Technical Report

Drinking Water System at the Kashechewan First Nation

Ministry of the Environment

Figure 3: Process Flow Diagram - Kashechewan Water Treatment Plant

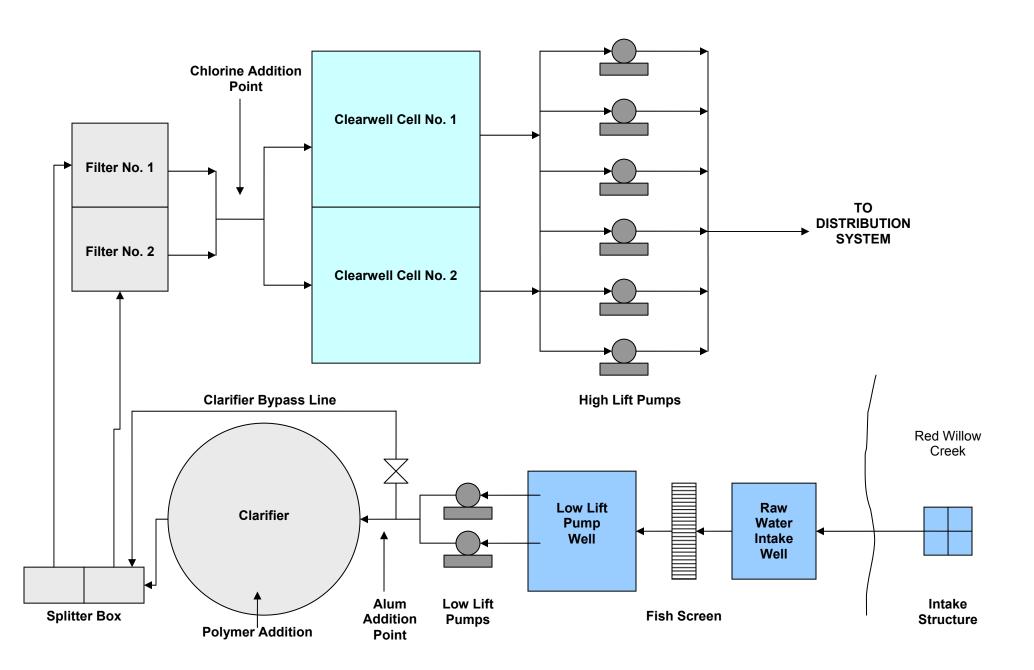
Water is pumped from the low lift well to the plant's single clarifier. A temporary polymer feed system is set up on the clarifier. Within the clarifier, the larger, heavier, particulate matter is allowed to settle to the bottom. The clarified effluent then flows into the plant's filtration system. Sludge at the bottom of the clarifier is discharged to the sanitary sewer.

The filtration system at the plant consists of two (2) sand and anthracite media gravity filters. Water from the clarifier enters into a splitter box and proportionate water enters into each filter by gravity. The filters have a backwashing system to routinely remove particles trapped in the media. Filter backwash cycle is initiated manually by the operator. The wastewater produced by backwashing the filters is directly discharged to the sanitary sewer.

The filtered water is chlorinated and flows into the plant's clearwell. The clearwell is comprised of two (2) separate cells, each with a volume of approximately 278 cubic metres. The clearwell serves two purposes: first, it provides contact time for the chlorine to disinfect the water, and second it provides treated water storage for the distribution system.

During the physical assessment of the treatment process works, a clarifier bypass was found to be installed so that raw water could be directed around the clarifier to the filters. This would facilitate maintenance of the clarifier without shutting the WTP. Water treatment plants that operate with a Certificate of Approval under the Safe Drinking Water Act are typically directed to remove or secure all such process bypass piping.

A number of potential cross-connections between treated and untreated/process waste water were also observed. It is understood that Northern Waterworks Inc. has provided a proposal to eliminate or secure the plant by-pass and all potential cross-connections.

- To ensure that the plant meets appropriate turbidity standards (i.e. 0.5 NTU 95% of the time), must:
 - o upgrade chemical storage and metering system with automation;

- o undertake inspection and replacement of filter media
 - o repair/replace backwash air scour system
 - o provide Programmable Logic Controller (PLC) to flow pace chemicals (coagulant, polymer and sodium hypochlorite).

- > In order to effectively monitor filter performance:
 - o provide continuous monitoring turbidity analyzer on each filter with a high turbidity alarm

- o provide Programmable Logic Controller (PLC) to operate filter backwash cycle with filter-to-waste procedure.
- ➤ To further ensure the system is able to continuously meet treated water disinfection standards:

- provide baffling in chlorine contact tank (clearwell) and relocate inlet/outlet pipes to enhance primary disinfection. This will help to ensure that the chlorine residual can be better controlled, especially in the winter months

- To ensure protection from in-facility contamination:
 - eliminate points of possible cross-connection within the water treatment plant
 - o adequately secure the clarifier by-pass so that it cannot be inadvertently opened.

Figure 4: Schematic View - Kashechewan Water Treatment Plant and Sewage Collection & Treatment System

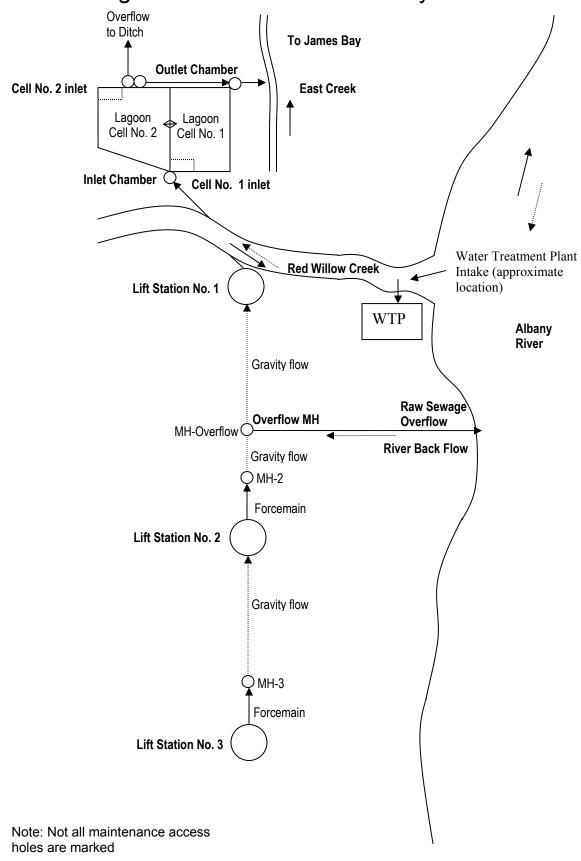
The sewage collection system and sewage lagoon were the only apparent point source threats that may impact the surface water quality. Refer to Figure 4 for further details.

The Kashechewan First Nation sewage collection system is illustrated in Figure 4. It is composed of three sewage lift stations (LS-1, LS-2 and LS-3), forcemains and gravity sewers. Sewage is collected in LS-3 from adjoining areas and pumped to a nearby maintenance hole (MH-3). Sewage then flows by gravity to LS-2 where it is again lifted to a nearby maintenance hole (MH-2). From MH-2, sewage flows by gravity to LS-1 via an overflow maintenance hole (MH-Overflow). The purpose of MH-Overflow is to direct raw sewage to the Albany River via the overflow sewer should LS-1 fail. During pump failures at LS-3 and LS-2, (as was the situation during this site visit), sewage flows to MH-3 and MH-2, respectively, by gravity.

- Repair/replace pumps in lift stations 2 and 3, maintain a spare parts inventory including at least one spare pump at all times, and perform other necessary maintenance to make lift stations functional.
- Repair/replace automatic shut-off device for lift station 1 to prevent the pumps from operating continuously when not required.
- Install alarms which are monitored in a staffed location (e.g. at the water treatment plant) that self-activate under abnormal conditions (e.g. pump failure, high water level) so that appropriate action can be taken as required.
- As an interim strategy, any raw sewage overflow into the Albany River should be responded to by ensuring immediate notification to water treatment plant staff.
- Repair/replace the overflow sewer and backflow prevention device because backflow potential exists.

Figure 5: Sewage Treatment Facility - General Layout

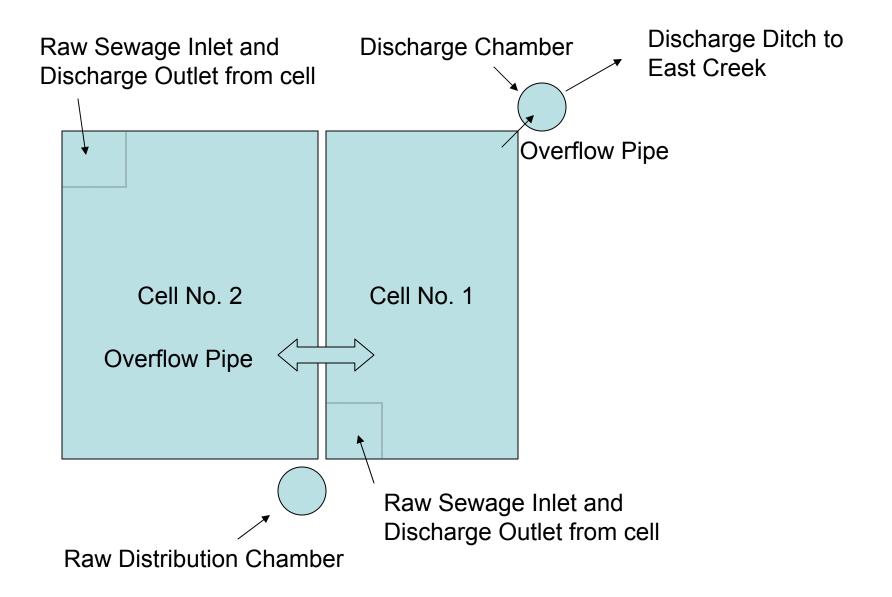
Raw sewage is pumped by LS-1 via a 250 mm polyethylene pipe running under Red Willow Creek to the distribution chamber located on the south side of the lagoons (Figure 5). This chamber houses four 250 mm gate valves. Two valves control the flow of water into the two existing cells. The two other valves were installed to control the flow of sewage into two future cells that have not yet been constructed. Sewage is either discharged into a bermed area within the south-west corner of cell 1 or the north-west corner of cell 2.

Following retention, the clarified effluent is discharged from either cell through the discharge chamber located at the north-east corner of cell 1 (Figure 5). This chamber houses four 400 mm diameter discharge pipes. Two of these pipes are used to convey treated sewage from cells 1 and 2. The two other pipes will convey treated sewage from two future cells that have not yet been constructed. The discharge pipe from cell 1 is controlled by a sluice gate in the discharge chamber. The discharge from cell 2 is controlled by a 400 mm diameter valve on the discharge pipe located inside the discharge chamber.

- Assess alternatives to reduce possibility of East Creek flow into Red Willow Creek, (e.g. install barrier in southern terminus of East Creek).
- Operate and maintain the sewage treatment facility in accordance with the Operations Manual (e.g. seasonal, 7-day discharge schedule, pre-discharge survey of East Creek).
- Develop and implement a contingency plan to be used in the event of backflow of lagoon effluent into Red Willow Creek (e.g. procedures for notification and evaluation of potential disinfection of the lagoon discharge).
- Assess and repair the breach and overflow pipe within the berm separating the two cells.
